C/015/036 Incoming  
#5721

26 September 2018

**Re: Response to Deficiencies in Application Castle Valley Mining, LLC, C/015/0036  
Waste Rock Site, Task ID#5721**

SECTION FF

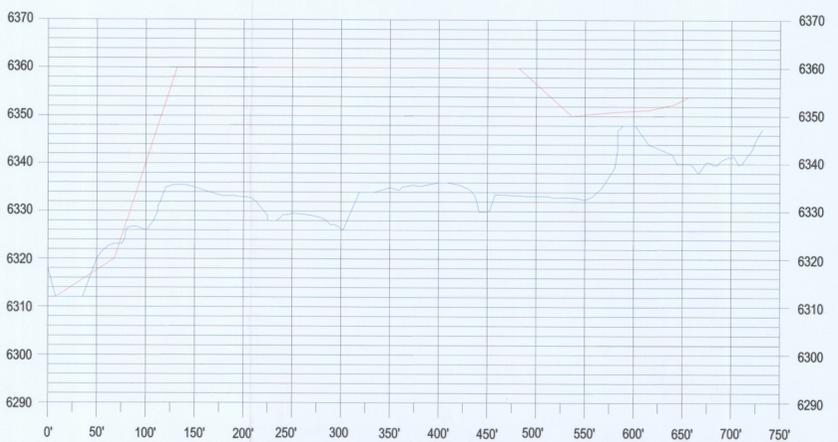
11. Please provide missing Plate 5-5 cross-sections F-F' and H-H'.

*Ans. Cross-sections F-F' and H-H' are found on Plate 5-4.*
